Town of Camden
29 Elm Street
Camden, ME 04843

Subject: Camden Harbor SHIP Grant Project
State WIN: 018534.12
Amendment No. 2

**ADDENDUM NO. 2
MAY 7, 2015**

**CAMDEN PUBLIC LANDING
IMPROVEMENTS**

SHEET TITLE:	STRUCTURAL DETAILS
PROJECT:	TOWN OF CAMDEN PUBLIC LANDING IMPROVEMENTS
DATE:	MAR 2015
CONTRACT NO.:	14-15
SHEET NO.:	S-4
REV.:	C

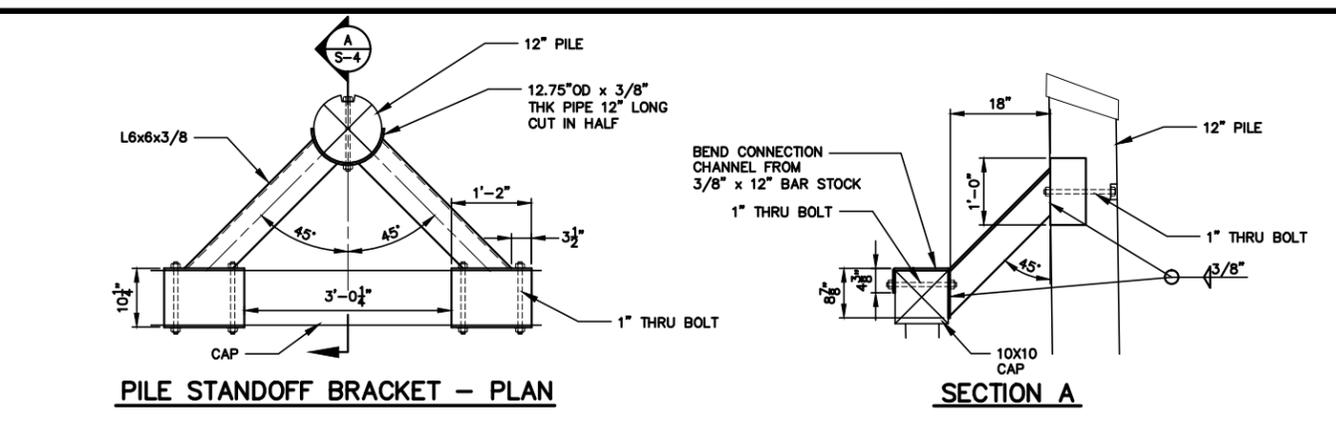
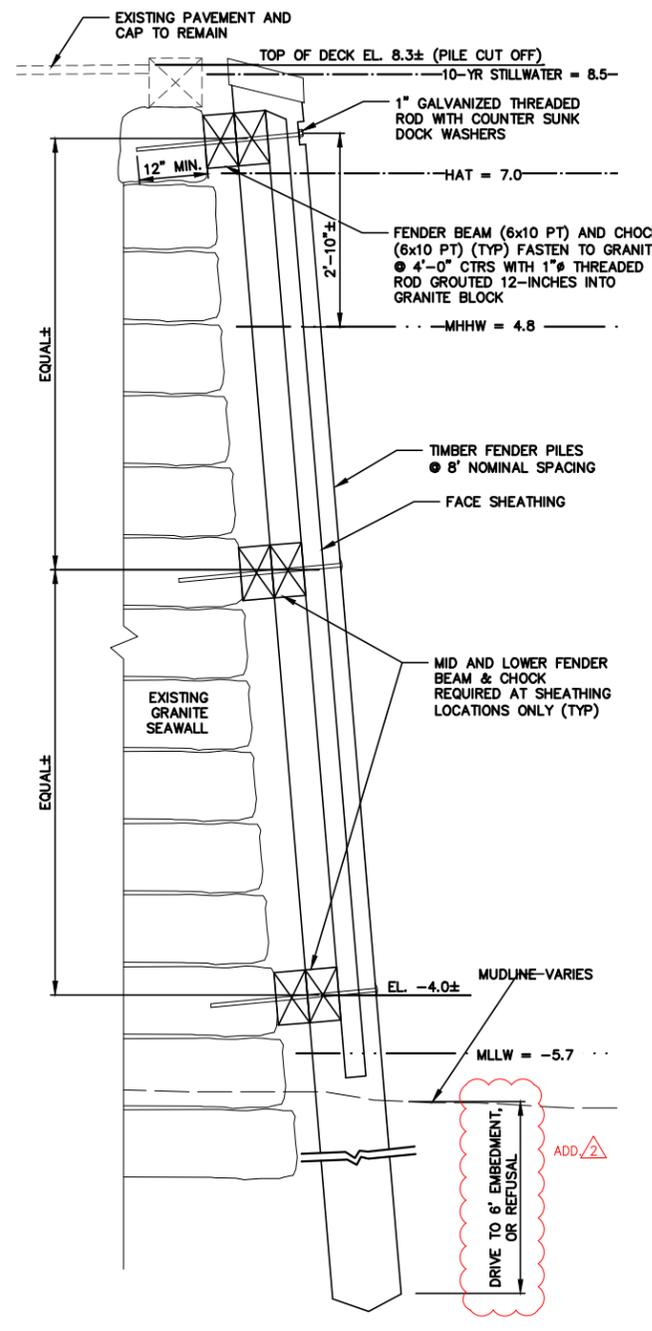
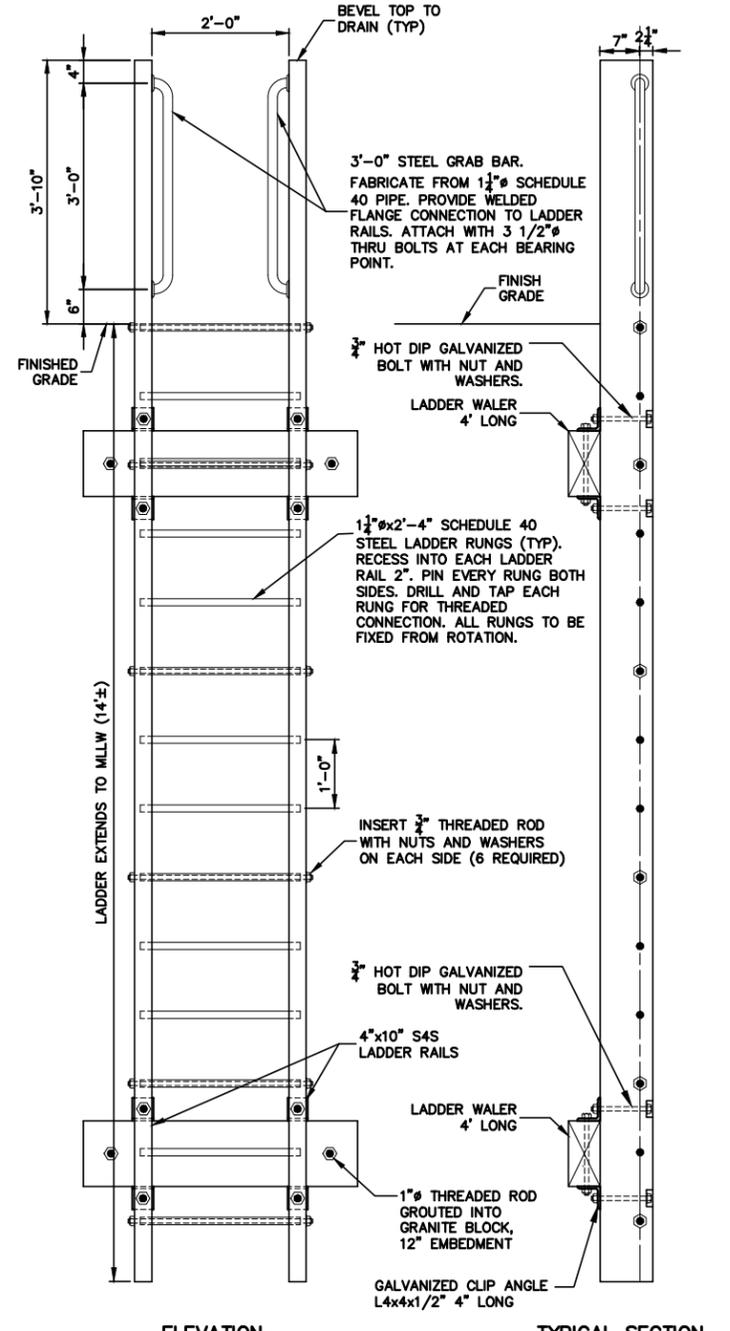
- On Sheet S-3, it shows the Face Sheathing going from P-9 to P-11. On sheet S-4 states that the Face Sheathing goes from Piles P-8 to P-12. Clarify.

27. **Question:** Item 528.493 Face Sheathing. Please describe how you envision using bolts to hold the sheathing in place. Shouldn't you be using lag bolts????

30. **Question:** On sheet S-4, on the fender pile detail, you show the top bolt being countersunk, do you want the two lower fender pile bolts to be counter sunk?

Response: *Face sheathing and mid and lower fender beam and chock are required from pile P9 to P11 only.*

Response: *Sheathing is shown in " Fender Pile Connection Detail" on Sheet S-4. Sheathing size and fastening requirements are included in the Timber Schedule and Fastener Schedule on Sheet S-1. See Appended drawings for updated Timber Schedule and Fastener Schedule.*

Response: *All exposed fasteners to piles and timber members shall be countersunk in accordance with Structural Notes, Sheet S-1.*

CAMDEN
PUBLIC LANDING
LIGHTING PLAN

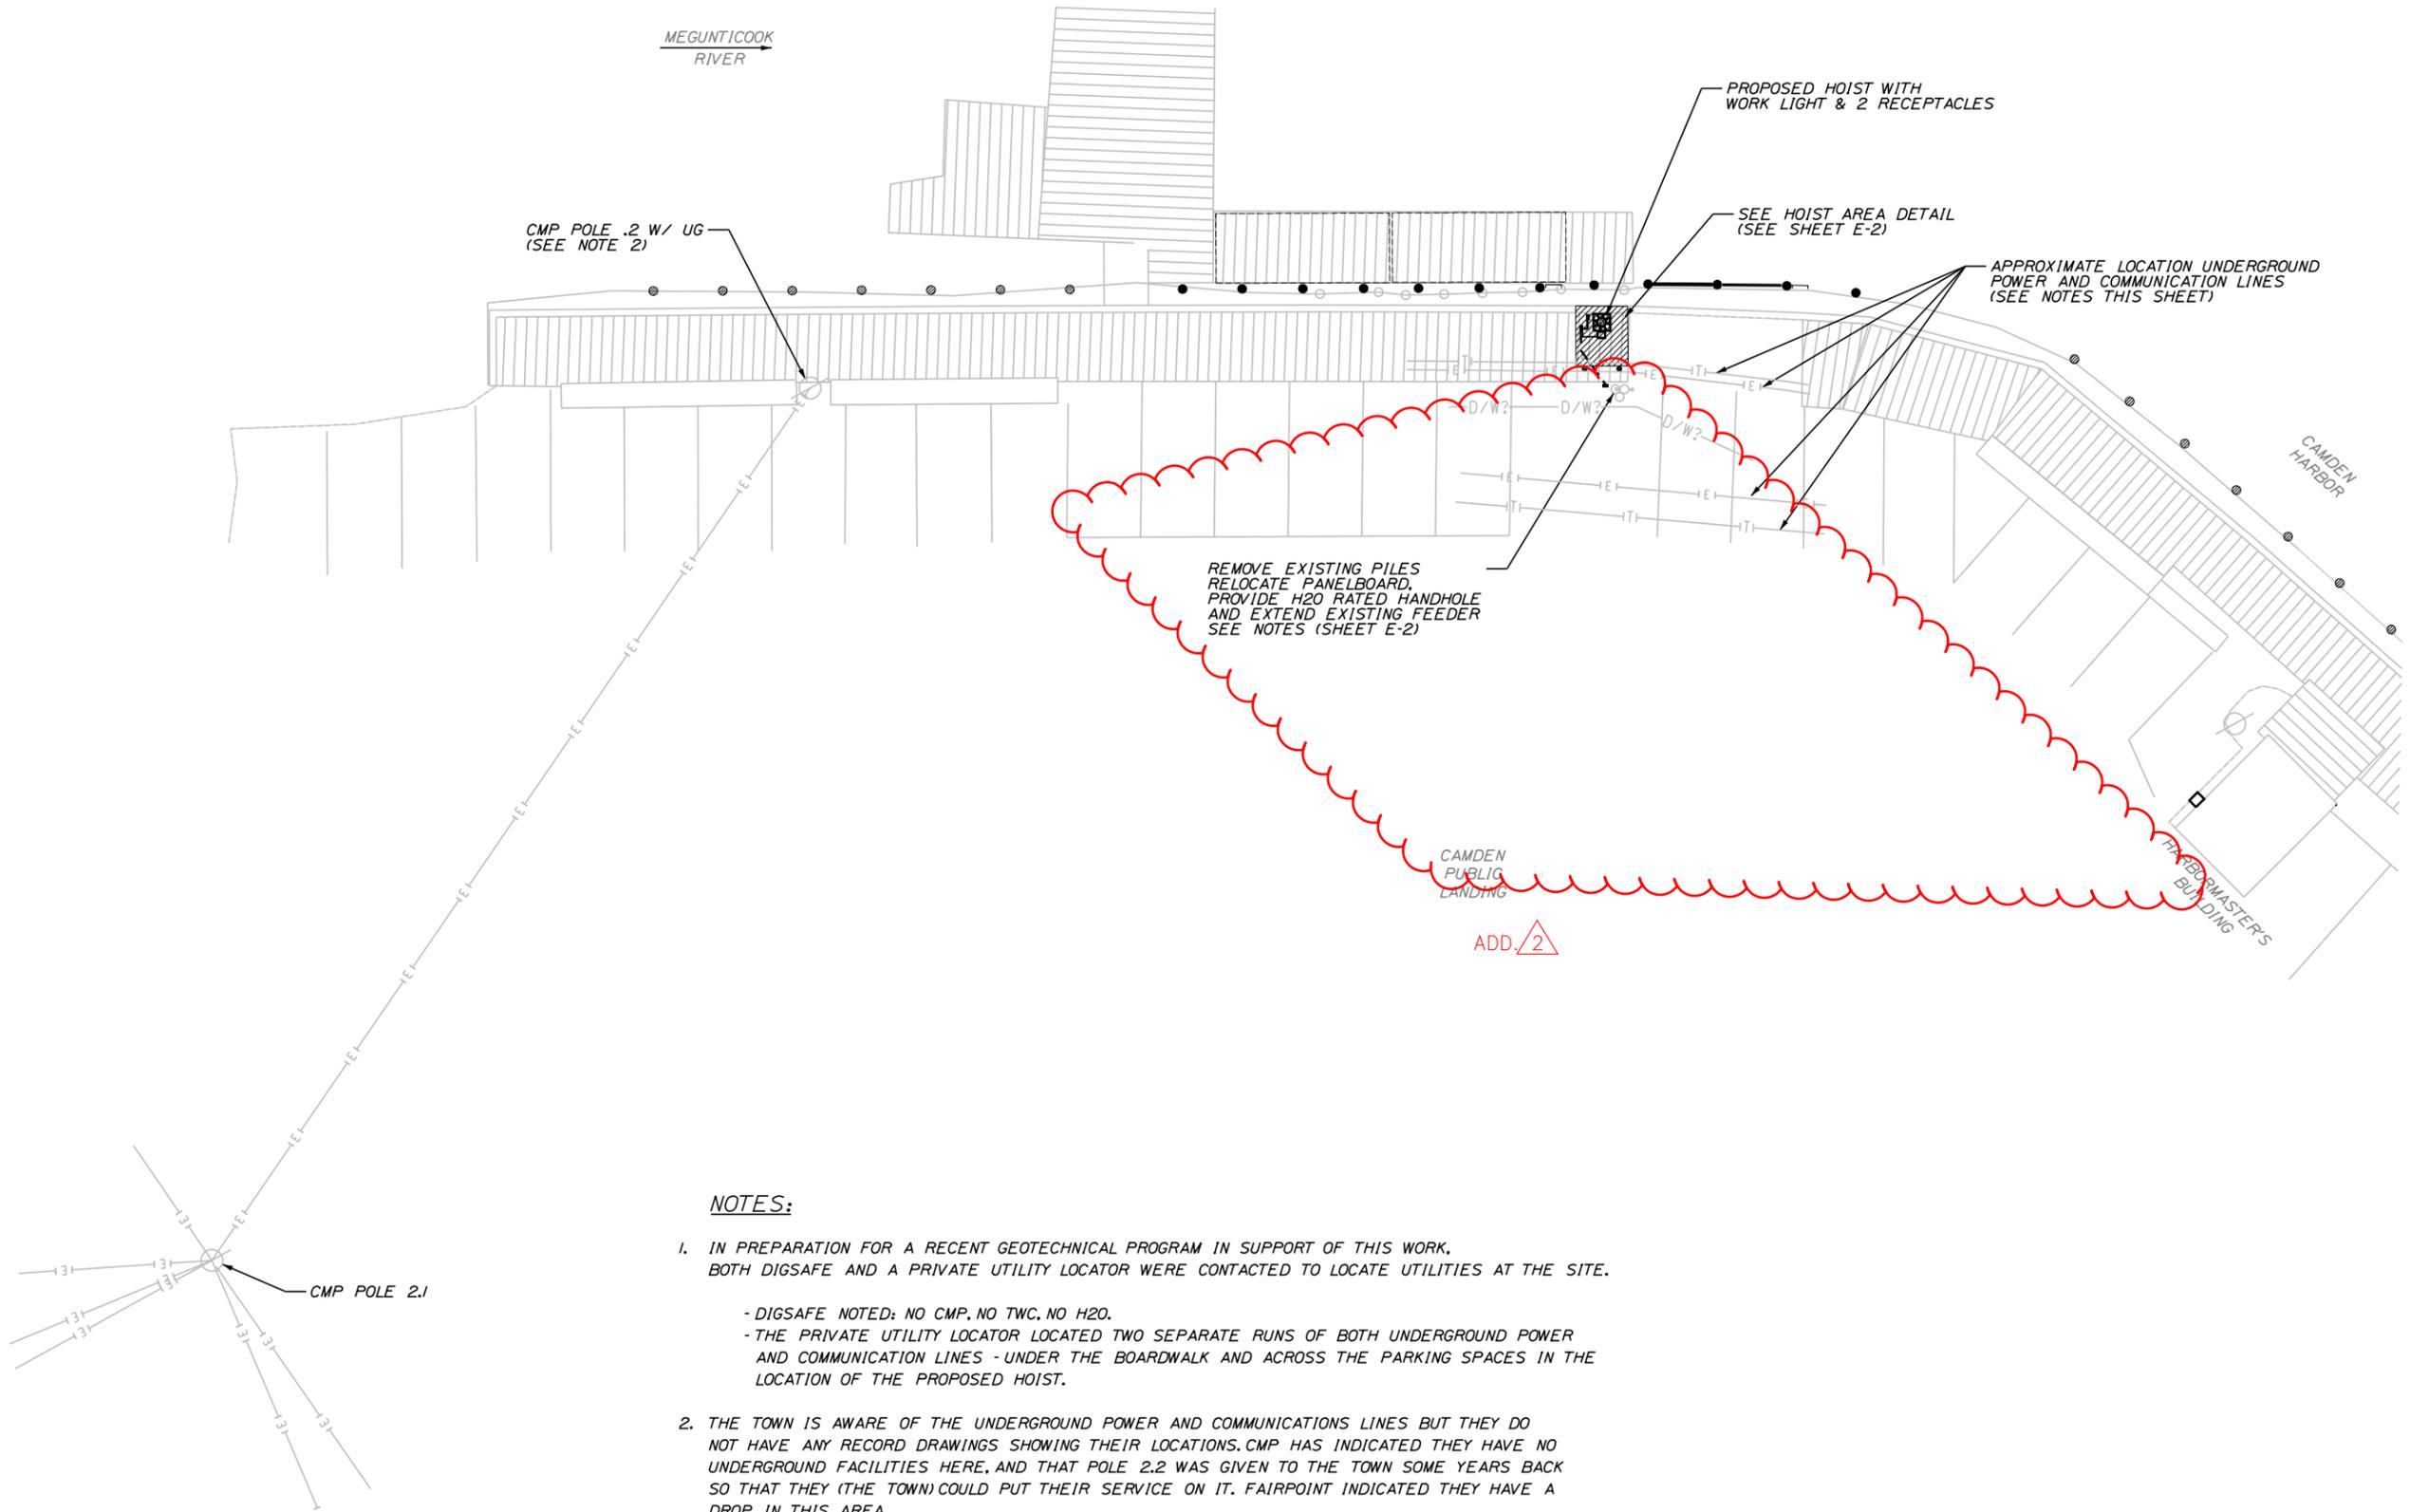
3. **Question:** Can the existing 240V power at the decorative light pole be used to power the hoist, eliminating the need for trenching and installation of new conduit?

24. **Question:** The specifications state that the Electrical Supply at the Hoist will be 240V, 20 amp single-phase electrical service. Is that available from the Harbor masters Office?

Response: *Yes. Supplemental Specification 634 has been revised as well as the electrical drawings; see attached.*

Response: *See revised electrical drawings, attached.*

RECEPTACLE MOUNTING DETAIL

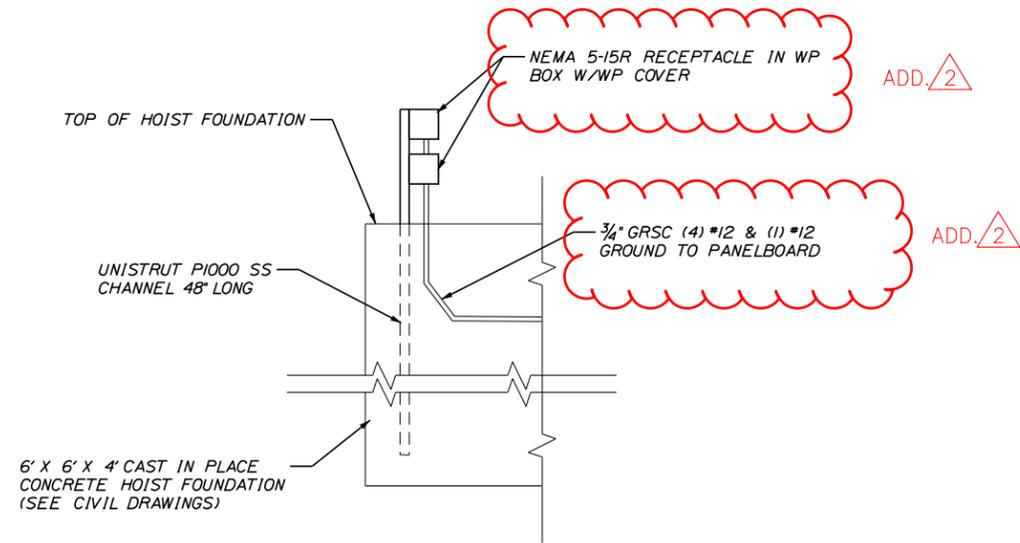
- a. Sheet T-1: Changed “PS&E SUBMITTAL April 21, 2015” to “ADDENDUM NO. 2 MAY 7, 2015”.
- b. Sheet S-1 (Rev. C): Added Survey Notes, Line 6. Revised Structural Notes, Timber Piles, Line 4. Revised Timber Schedule. Revised Fastener Schedule.
- c. Sheet S-2 (Rev. D): Added location of Boring B-1.
- d. Sheet S-3 (Rev. C): Added location of Boring B-1 and interpretive subsurface information. Revised hoist foundation detail and backfill notes.
- e. Sheet S-4 (Rev. C): Revised Notes on pile embedment and limits of face sheathing.
- f. Sheet E-1 (Rev. 1): Revised electrical supply to be from panelboard on decorative pole rather than from panelboard at Harbormaster’s building.
- g. Sheet E-2 (Rev. 1): Removed table in upper left corner; revised receptacle mounting detail and hoist area detail; revised Notes 4, 5, 7, 8, and 9.
